# City of Richmond

## Report to Development Permit Panel

**File:** DP 13-637372

**Re:** Application by Dava Developments Ltd. for a Development Permit at 22560,  
22600 and 22620 Gilley Road

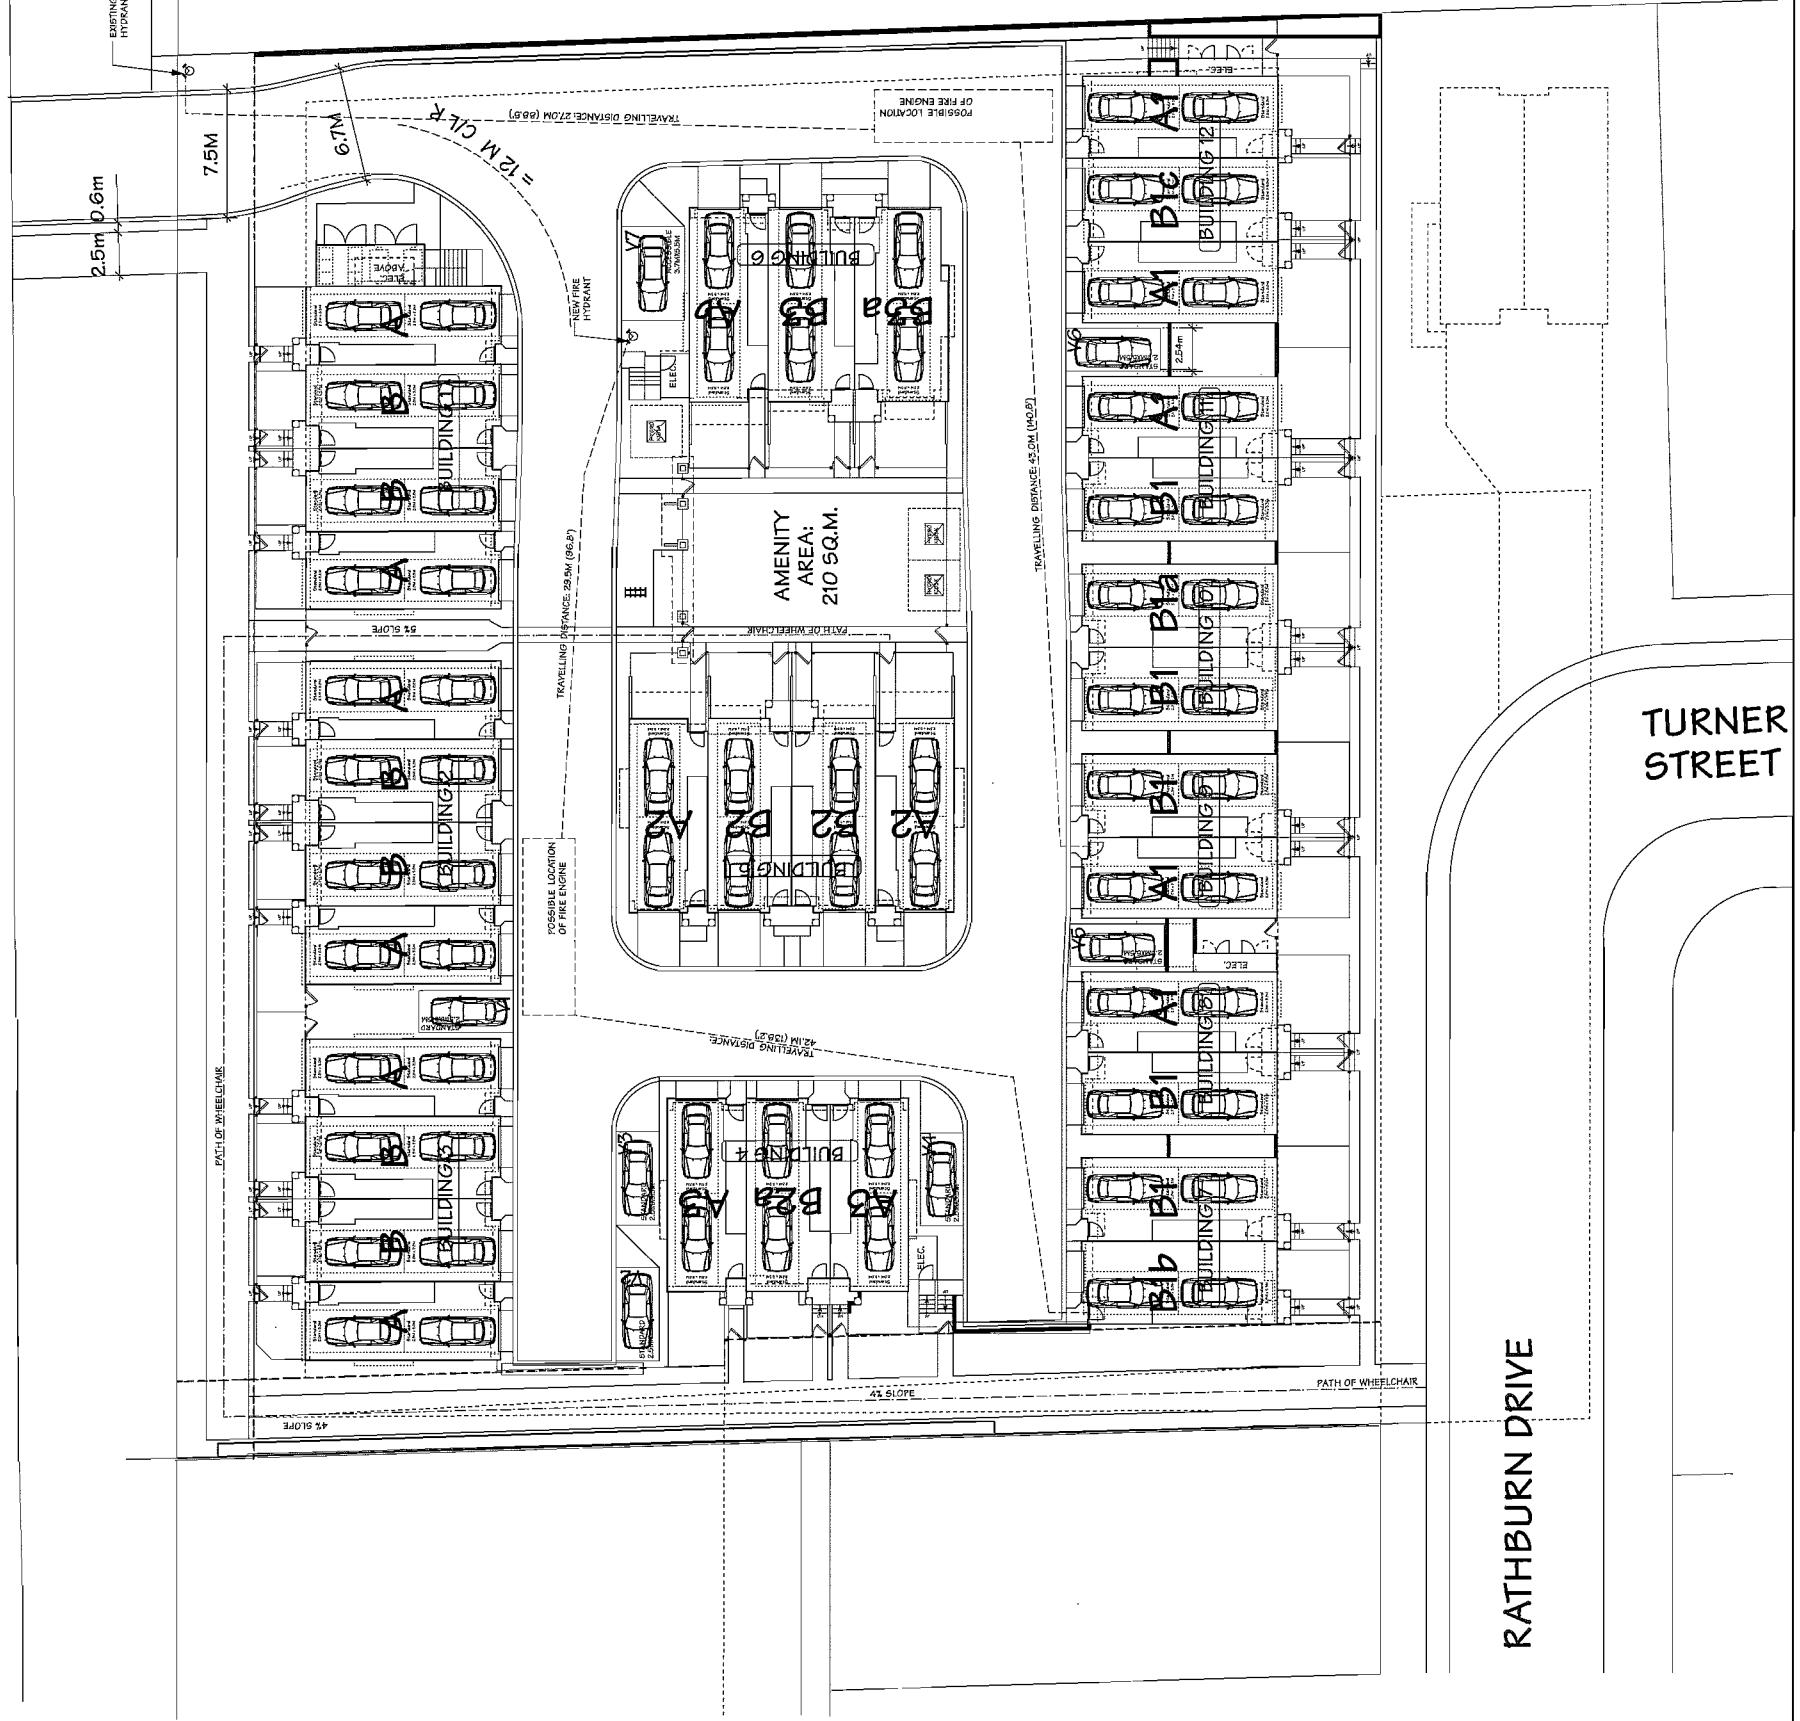
- review the location and manoeuvrability of the visitor parking stalls;

- consider an additional convertible unit in the proposed development;  
*Consideration of additional convertible unit was undertaken. Proposed development consists of all 3 storey units which is not ideal for a potential accessible occupant. All units are designed to have age-in-place features such as lever type handles to accommodate an older demographic. We feel that proposing one convertible unit is adequate.*
- look at pedestrian permeability/connectivity at the south end of the driveway access/egress to Gilley Road; consider opportunity for a sidewalk;

- note the lack of public connection on the east side of the proposed development.

*Relocation of visitor parking stalls were studied. No opportunity to relocate visitor parking stalls without negatively impacting the outdoor amenity area. Proposed visitor parkings stalls proposed at same locations. See site plan. (Sheet A1.0)*

*Opportunity for sidewalk at the south end of the drive access/egress to Gilley Road is unattainable. Tight quarters between building and main entry drive aisle limits the allowance for access to garbage/recycling, sidewalk while maintaining landscaping features at the entry point. A 2.0m wide pedestrian pathway has already been proposed between building 1 & 2 via sidewalk from Gilley Rd. See site plan. (Sheet A1.0)*

*Additional pedestrian connection provided at the south east corner of site near Bldg. 12. See site plan. (Sheet A1.0)*

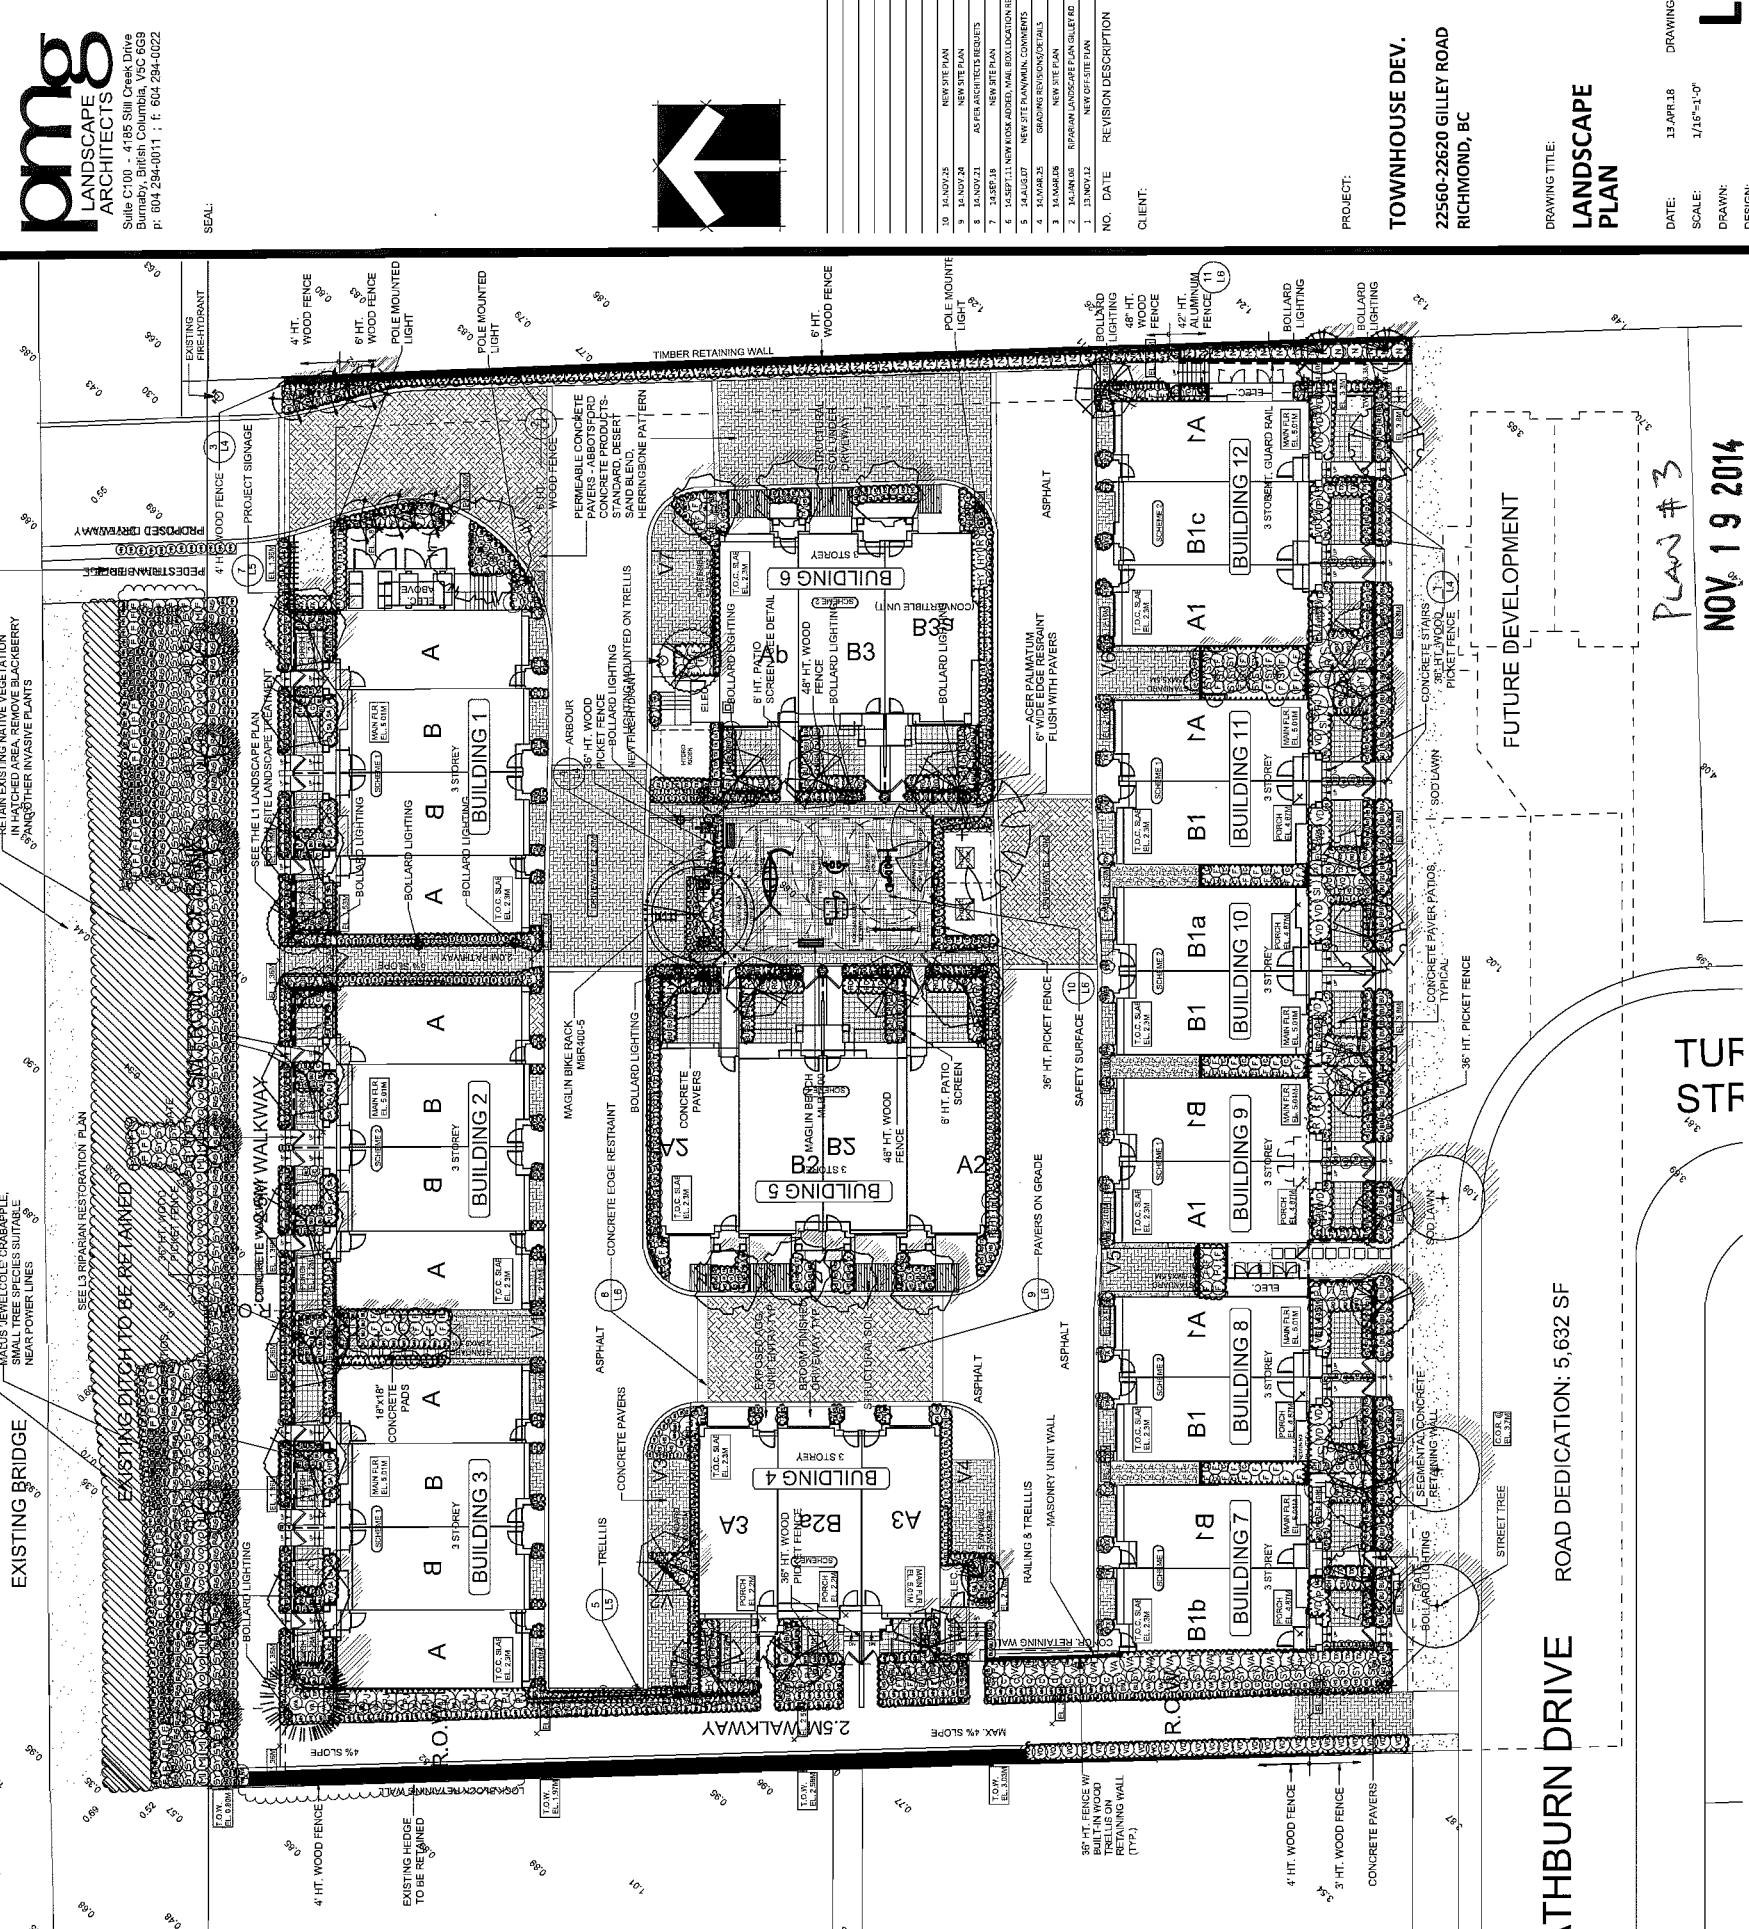
- reduce the barrenness of the subject site and address the lack of landscaping; would like to see more concrete pavers and less asphalt on the proposed development;

- consider opportunities for planting more big trees on the site, e.g. between Buildings 4 and 5 and on the east side of Building 6;

*Permeable concrete pavers enlarged at key points throughout the subject site. Permeable pavers proposed at main entry drive aisle, adjacent to outdoor amenity area, and adjacent to unit entrances from the internal roadway. Buildings 1-3, and 7-12 are now also proposed with pavers at the drive way aprons. Additional trees proposed along internal driveway near the entries to building 5 & 6. See landscape plan. (Sheet L1)*

*Additional trees proposed along internal driveway near the entries to building 5 & 6. Opportunity for additional trees near building 4 is restricted due to limited space. See landscape plan. (Sheet L1)*
